SERVICE LETTER 191

FIRE BOSS WATER SCOOP SWITCH REPLACEMENT

Aircraft Makes/Model(s):	Float Model(s):	Compliance: As required	By: MAS
AT-802 & AT-802A	10000A	Part Number: 1009904	Approved: SDW
		Date: 3/13/2026	Revision: D.1

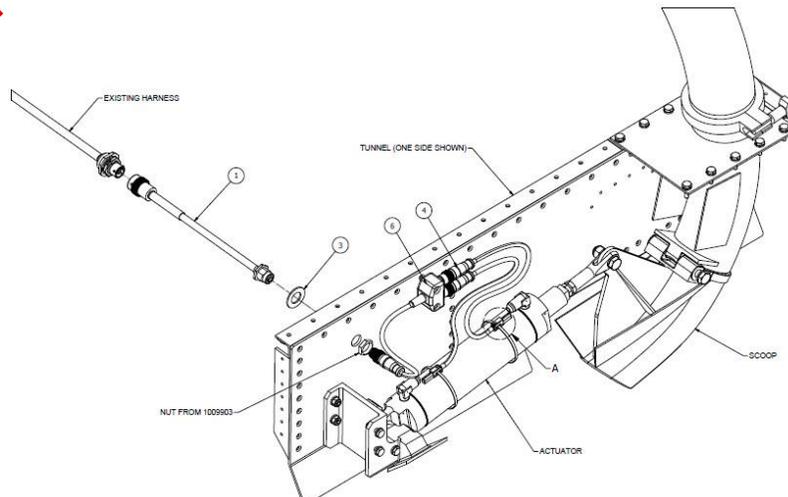
1. Gain access to water scoop system baggage area from aft bulkhead panel. Then remove water scoop tunnel covers.

2. Remove hydraulic actuator assembly from tunnel to facilitate installation of new switches.
3. Disconnect existing Canon plug from scoop tunnel side wall. Remove and discard switch harness from hydraulic scoop actuator.
4. Connect Cannon plug to new adapter harness (1009903).
5. Zip tie up to existing wires/hydraulic lines.

6. If not already done, mark the Splitter 2 Branch 4 Wire (U0163-11) with "DN" at the #1 position, and "UP" at the #2 position. The "UP" Switch will be towards the aft end of the float and the "DN" switch will be towards the fwd end of float.

7. Open up the diameter of the Washer (NAS1149D0963J) to 19/32, to fit Adapter receptacle.
8. Remove Rubber O-Ring from rear mount receptacle of Harness Adapter. Replace with modified Washer.

9. Insert Rear Mount Receptacle of Harness Adapter (1009903) through tunnel access hole from outside. Secure with nut and taper facing inwards (helps to center connector in larger hole). Assemble wet with PR-1422 or equivalent.

10. Ensure connector end and internal area remain free of sealant.
11. Remove left hand screws from Inductive Magnet Sensors (S4685792). Mount switches on scoop hydraulic actuator using ASB-6 Straps (M6965106) and Cord Sets (S693351). See Detail A.

12. Re-install hydraulic actuator assembly with previously removed hardware.
13. Connect corresponding switches to splitter. Connect splitter to bulkhead connector.

14. Secure Splitter Harness and Switch assemblies with Plastic Cable Tie (PLT-25-M).
15. Operational check:
 - a. With scoops in Up position, adjust "UP" Switch forward or aft to make contact. LED will be illuminated.

- b. With scoops in Down position, adjust "DN" Switch forward or aft to make contact. LED will be illuminated
 - c. **Note:** Ensure the Switch LED comes on at the same time the scoop cylinder bottoms out. Timing of the scoop travel for full up or full down limits should be approximately $\frac{3}{4}$ of a second.
